# PERSIMMONS CONSTRUCTION PLAN

C8-2019-0080.1B.SH

*Jonathan Garner*

# VARIANCE REQUEST

**CUT EXHIBIT**

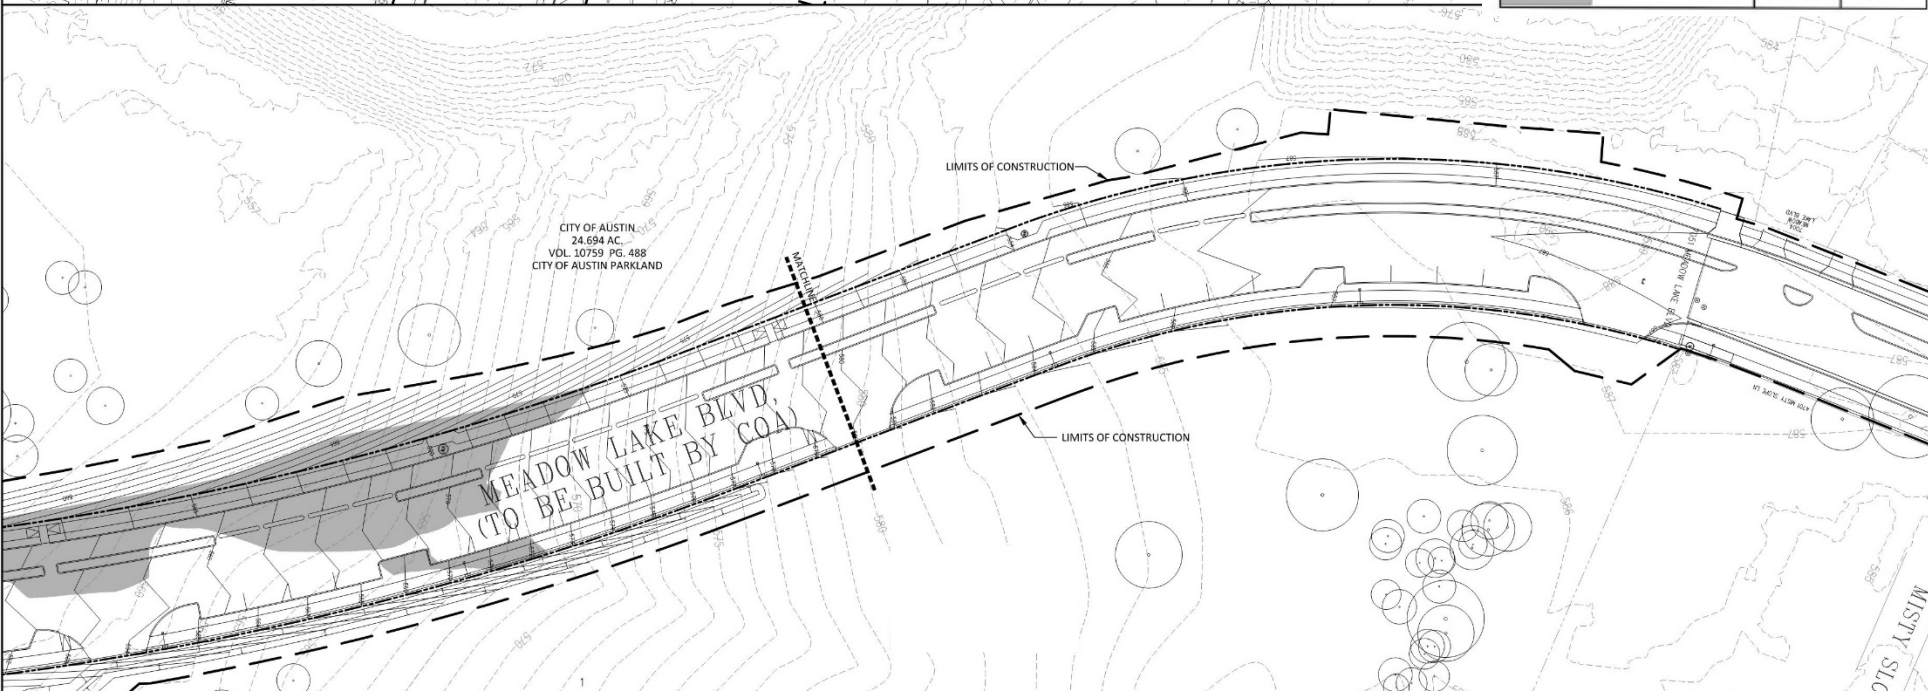
AREAS WHERE CUT IN EXCESS OF FOUR FEET EXTENDS OUTSIDE THE ROW AND IS WITHIN 100 FEET OF CLASSIFIED WATERWAY, APPROXIMATELY 5.5 FEET IN DEPTH

**Roadway construction crossing a classified waterway occurs all throughout the City of Austin utilizing methods that do not require a variance to City Code requirements. A Code compliant construction method would eliminate the need for the variance request and would not deprive the applicant of a privilege to construct a roadway crossing a classified waterway.**

**A construction method that modifies the channel margins, alters the natural flow velocity, and removes hydric soils and vegetation does not provide greater overall environmental protection than a construction method that is achievable without the variance.**

**The amount of cut in excess of four feet required for the construction of the crossing occurs within the minimum setback of the waterway buffer and the erosion hazard zone adjacent to the classified waterway. Grading at a depth beyond that allowed by Code within these sensitive environmental areas does not constitute the minimum deviation from the code requirement.**

**The grading associated with the placement of the concrete box culverts, headwalls, and wingwalls will remove soils and existing vegetation and destabilize the stream bank, alter the flow velocity in the channel resulting in downstream incising and bank erosion, and modify sediment deposition patterns beyond natural processes.**

**Bank erosion and sediment deposition are two leading causes of degraded water quality in creeks. Siltation can lead to murky water that smothers aquatic life habitat, reduces visibility for aquatic organisms to find food, prevents sunlight from reaching aquatic plants, and conveys other nutrients, pesticides, or toxic compounds that lower the water quality.**

- **Staff has determined the required Findings of Fact have not been met, and does not recommend approval of the variance request.**
